Applicant : Noriyasu Sakai et al.
Serial No. : 10/667,681
Filed : September 22, 2003
Page : 9 of 15

Amendments to the Drawings:

Annotated Sheet Showing Changes

FIG.13A

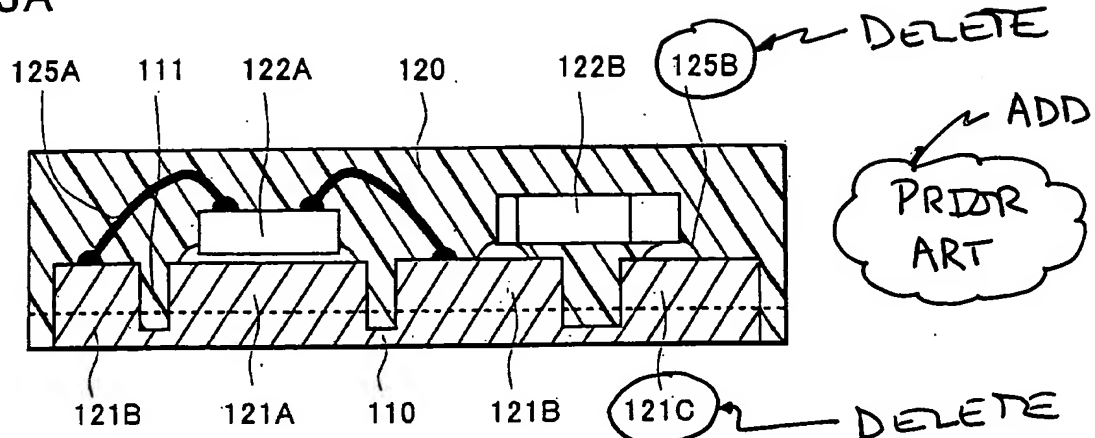
The Office Action indicated that FIGs. 13A-13C should be designated by a legend such as --Prior Art-- because only that which is old is illustrated. Applicants have amended Figs. 13A-13C to include that designation.

The drawings were objected to because certain reference numerals were identified in FIGs. 13A-13C, but were not identified in the specification. Applicants have deleted those reference numbers from FIGs. 13A-13C and request acceptance of FIGs. 13a-13c.

In Figure 13A, reference numerals 121C and 125B have been deleted and the designation "Prior Art" has been added.

FIG.13B

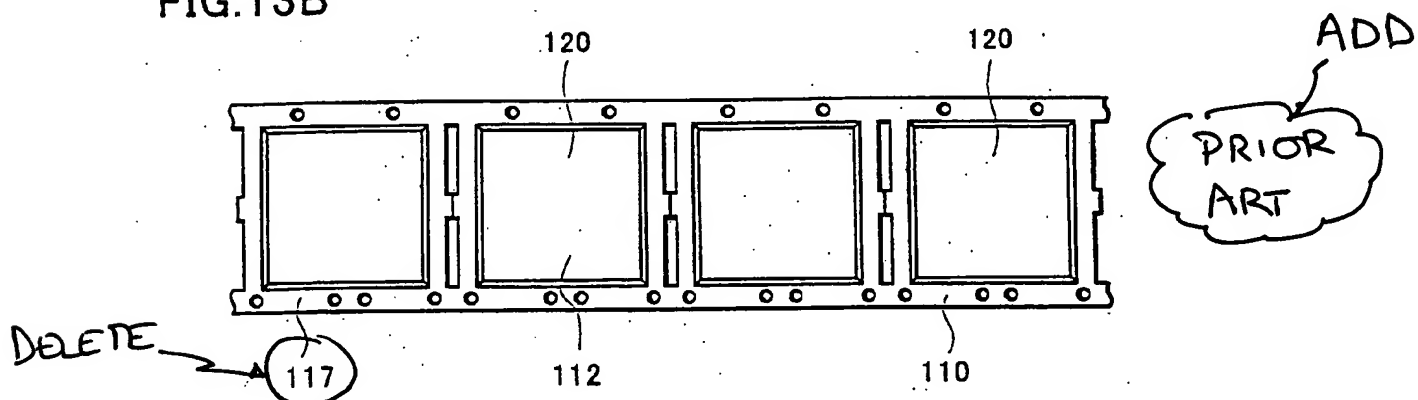
In Figure 13B, reference numeral 117 has been deleted and the designation "Prior Art" has been added.
